REQUEST

Current Zoning: N1-A (neighborhood 1-A)
Proposed Zoning: N1-F(CD) (neighborhood 1-F, conditional)

The petition proposes to develop two triplex buildings and one quadplex on two parcels currently developed with two single family detached homes.

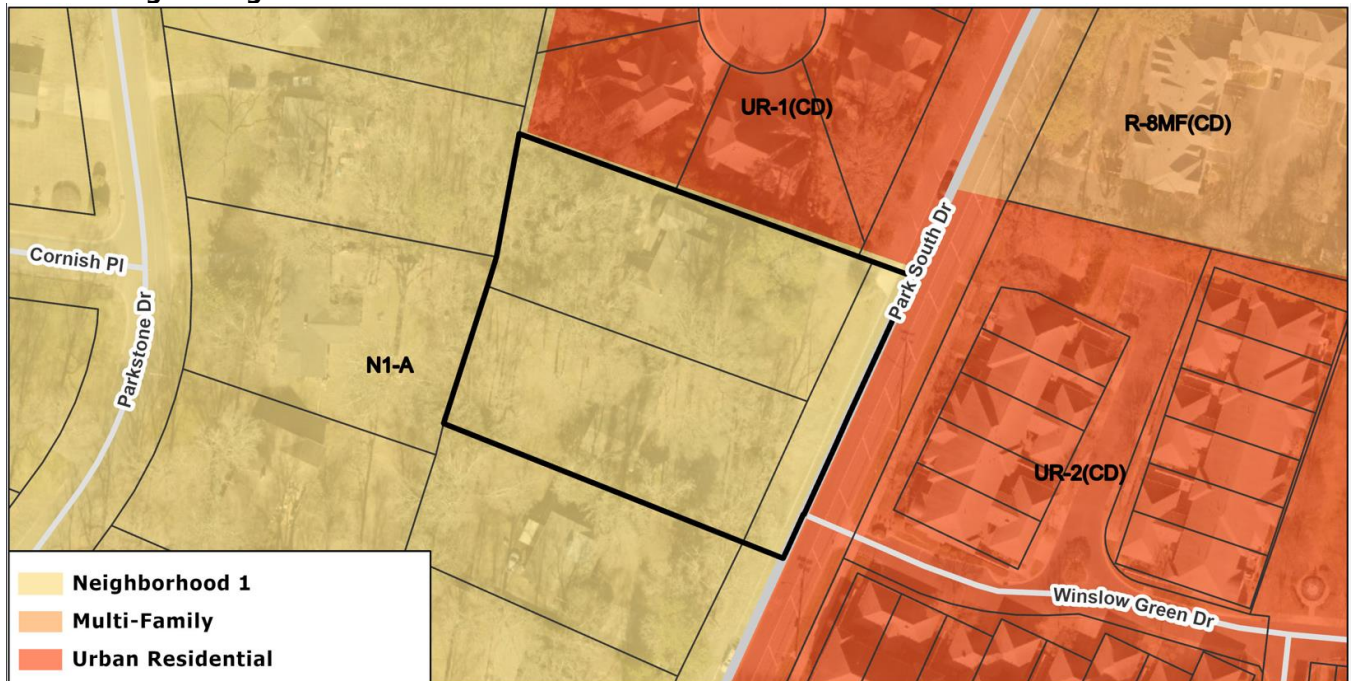
1. ~~Revise the proposed driveways for the individual units to be compliant with Article 19.6.A.1.a of the UDO.~~ **Addressed**

2. ~~Clarify if the tree save area shown on the site plan is outside of the demolition plan.~~ **Addressed**
3. ~~The replanted tree save area will have to be at a higher rate than the required minimum of 15% of the site. Increase the proposed tree save on the plan.~~ **Addressed**

4. ~~The dimension for the proposed back of curb to the center line must be shown on the site plan as well as the buffered bike lane that is required per the Charlotte Streets Map cross section.~~ **Addressed**

5. ~~Revise conditional notes from note K in the transportation provisions to remove the wording, "as generally depicted on the site plan," since this commitment is not depicted on the site plan.~~ **Addressed**
